# Access Compliance Report

## Public Rights-of-Way

### (Curb Ramps)

Intersection ID: 17882	Main Street: CHELSEA_DR	Cross Street: WALES_AV	Location: NE
ADA ID: 0CDED7866EF7	Ramp Type: BlendTrans1	Initial Pass/Fail: Fail	Overall Compliance: No
		Severity Score: 25

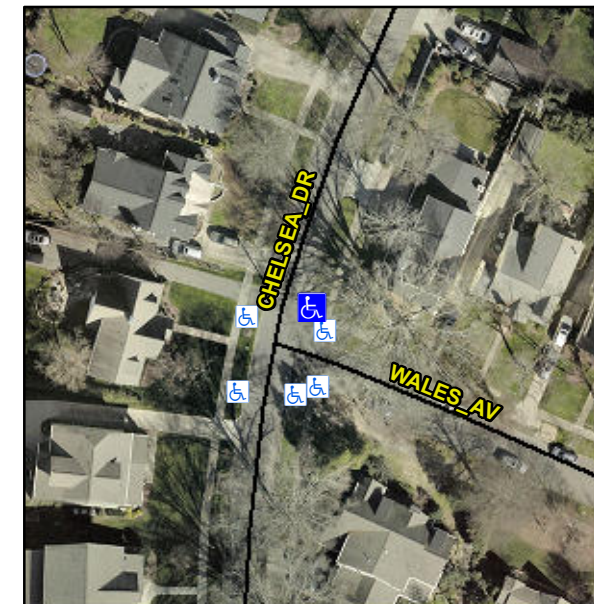
Compliance	Description	Data	Compliance	Description	Data
N/A	Ramp Length (in)	105.0	Yes	BlendTrans Slope (%)	4.4
Yes	Ramp Width (in)	53.0	No	BlendTrans XSlope (%)	7.3
N/A	Flare Type LT	N/A	N/A	Flare Type RT	N/A
N/A	Flare Slope LT (%)	N/A	N/A	Flare Slope RT (%)	N/A
N/A	Flare Traversable LT?	N/A	N/A	Flare Traversable RT?	N/A
N/A	Landing Length (in)	N/A	N/A	DWS Provided?	N/A
N/A	Landing Width (in)	N/A	N/A	DWS Contrast?	N/A
N/A	Landing Slope (%)	N/A	N/A	DWS Length (in)	N/A
N/A	Landing X Slope (%)	N/A	N/A	DWS Full Width?	N/A
N/A	Landing Curb? (Y/N)	N/A	N/A	DWS Offset (in)	N/A
N/A	Shared Landing?	N/A			
N/A	Gutter Ponding?	N/A	N/A	Gutter Slope (%)	N/A
N/A	Gutter Lip Ht (in)	1.0	N/A	Gutter X Slope (%)	N/A
N/A	Painted X Walk1?	No	N/A	Painted X Walk2?	N/A
	X Walk 1 Direction	To W		X Walk 2 Direction	N/A
	X Walk 1 Width (in)	N/A		X Walk 2 Width (in)	N/A
	X Walk 1 Slope (%)	0.5		X Walk 2 Slope (%)	N/A
	X Walk 1 X Slope (%)	2.5		X Walk 2 X Slope (%)	N/A

**Remove & Replace Curb Ramp With Two New Directional Ramps or Equivalent.**

**R304.5.3**
